APP-GW-GLN-014-NS, Revision 0

“AP1000 Integrated Head Package”

TITLE: **AP1000 Integrated Head Package**

# AP1000 Standard Combined License Technical Report

Figure 3.9-7

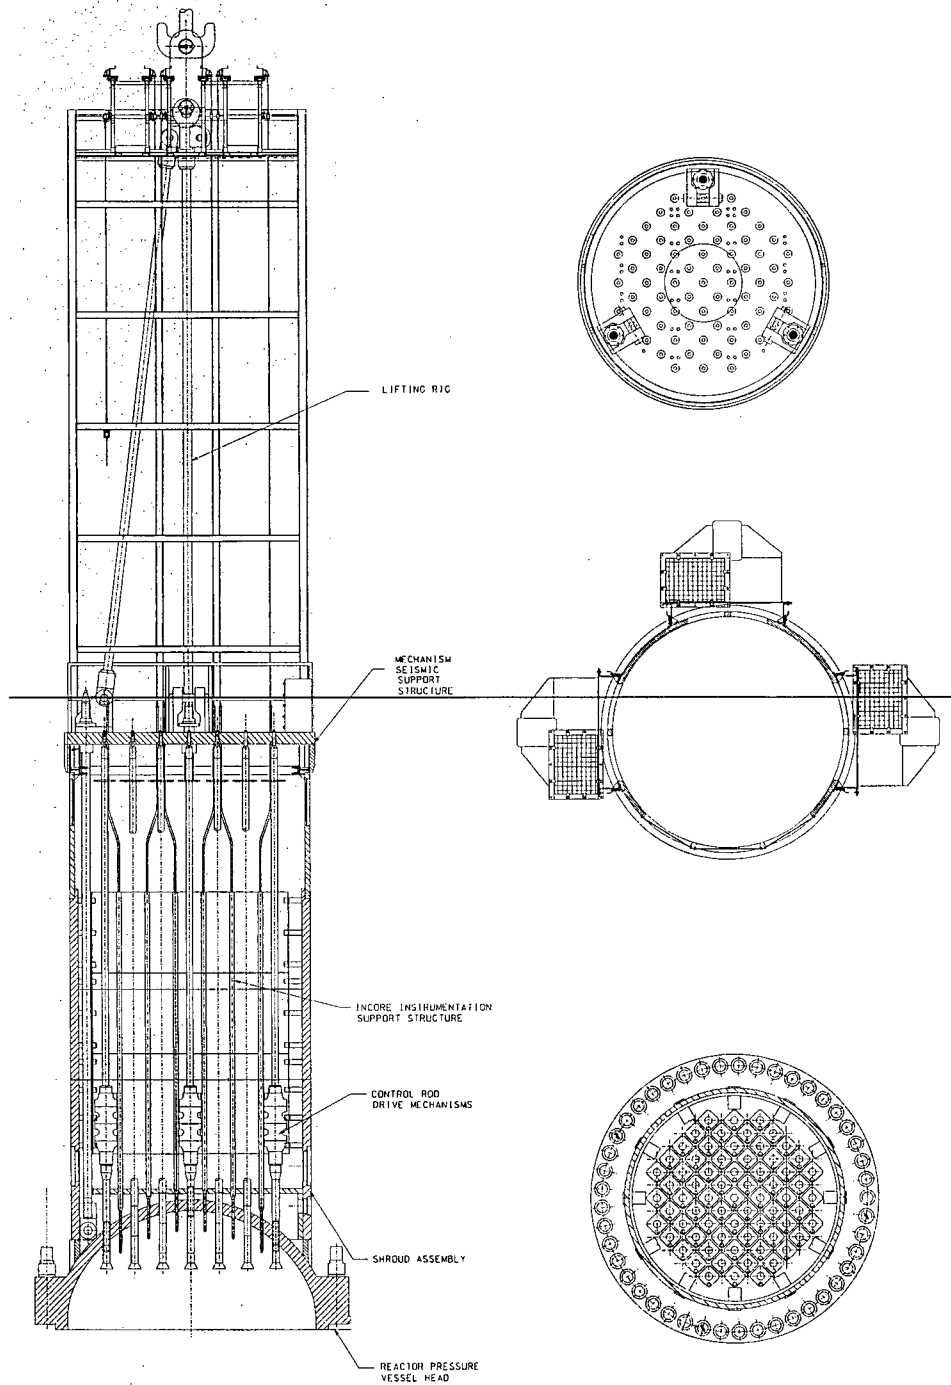
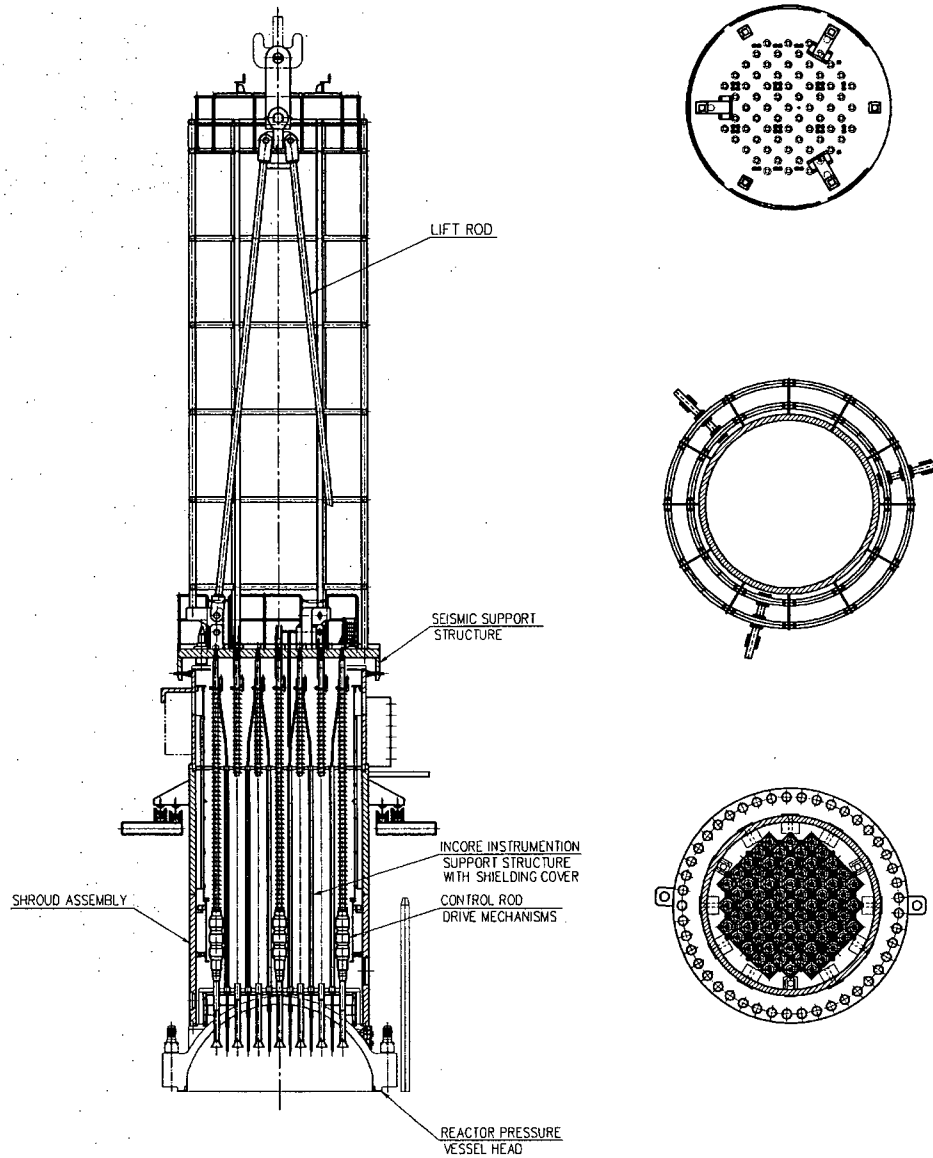
The control rod drive mechanism (CRDM) cooling fans are no longer supported on the Integrated Head Package, but on an adjacent structure. This reduces the size and load to be picked up by the polar crane. A cable bridge is no longer used for instrumentation and power cable management. A stud hoist rail system is used to support individual stud hoist tensioners. Shielded covers are provided for the in-core instrument guide tubes to enhance radiation protection during refueling operations.

Stud Hoist Rail – A stud hoist rail has been added to Figure 3.9-7. The stud hoist rail is used to support individual stud hoist tensioners used during refueling operations.

Revise Figure 3.9-7, "Integrated Head Package," as shown on the following page, to reflect its current configuration with CRDM cooling fans on an adjacent structure.
